AMENDMENT OF SOLICITATION/MODIFICATION OF CONTRACT		BPA NO.	1. CONTRACT ID CODE	PAGE 1	OF PAGES 18
2. AMENDMENT/MODIFICATION NO. A00003		3. EFFECTIVE DATE 05-19-2015	4. REQUISITION/PURCHASE REQ. NO. 675-15-1-3275-0001	5. PROJECT NO.(If applicable) 675-15-601	
6. ISSUED BY Department of Veterans Affairs Orlando VA Medical Center 5201 Raymond Street Orlando FL 32803		CODE	7. ADMINISTERED BY (If other than Item 6) Department of Veterans Affairs Network Contracting Activity 8 (NCO 8) Orlando VA Medical Center 5201 Raymond Street Orlando FL 32803		CODE 00675
8. NAME AND ADDRESS OF CONTRACTOR (No., street, county, State and ZIP Code) To all Offerors/Bidders			(X)	9A. AMENDMENT OF SOLICITATION NO. VA248-14-R-1902	
			X	9B. DATED (SEE ITEM 11) 05-19-2015	
				10A. MODIFICATION OF CONTRACT/ORDER NO.	
				10B. DATED (SEE ITEM 13)	
CODE		FACILITY CODE

The purpose of this amendment is to:

- 1) Provide the RFI tracking log dated 05/19/2015,
- 2) Provide drawings and description of equipment in place. See attachments 1-10 of this amendment.

TITLE		DATE	
SCPS-12 DEADFRONT PADMOUNTED		060898	
SWITCHGEAR 15KV, 95KV BIL, 600AMP		SCALE 1/30	
FEDERAL PACIFIC COMPANY		DRN BY RWP	
Electro-Mechanical Corporation - Electrical Group		CHK BY RGN	
JOB NO. 37-19		FILENAME 1912A001	
DWG NO. B37-1912-001		REV. A

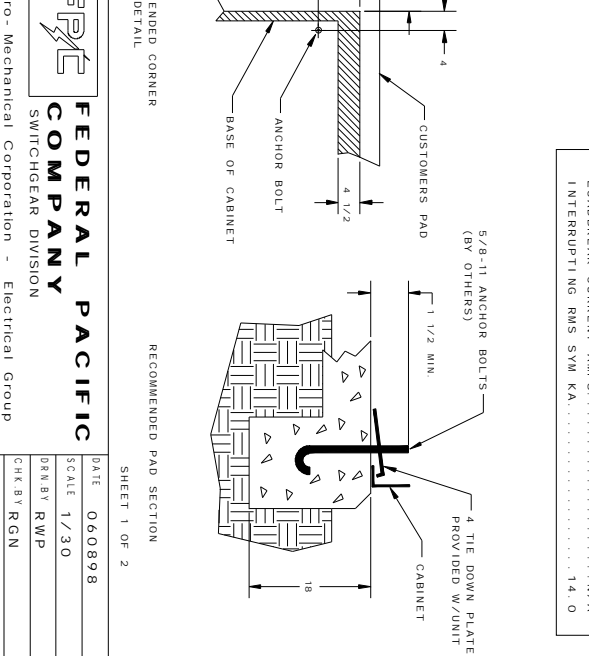
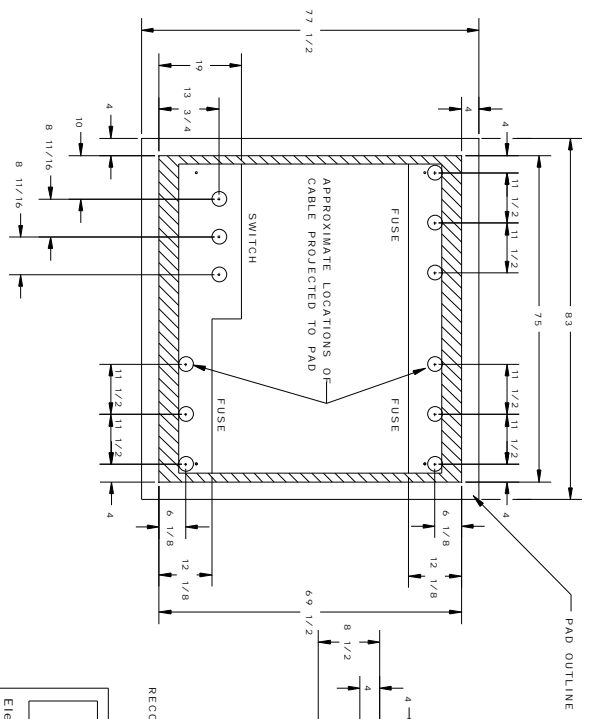
4.	(2) The existing equipment replacement is difficult to accomplish without name brands and model numbers of the pieces and parts that will be needed for a complete replacement. Does The VA have this information? If so, please forward to us.	Blue Cord Design & Construction	05/04/15

11.	Request the Government provide As-Builts	Contract &	05/05/15

Response	Please refer to attachments: #1, 2, 4, 5, 6, 7, 8-10 contained in amendment A00003.		
5.	(3) With the uncertainties expressed above we have many questions and will not know how many need to be asked until we reexamine the equipment and are able to determine brand names and model numbers of the equipment. With this in mind, the RFI deadline of tomorrow is too soon. Can the RFI deadline be extended about a week?	Blue Cord Design & Construction	05/04/15

Purchasing Solutions	
Response	Please refer to Attachments#1, 2, 5, and 8-10 contained in amendment A00003.		
12.	(1) Based on our market research, there will be a material delivery lead time of 14 to 16 weeks after receipt of order for the specified load break switches. The order cannot be placed until after applicable submittals are approved by the VA; therefore, we request the contract performance period be extended to 180 calendar days.	Contract & Purchasing Solutions	05/07/15
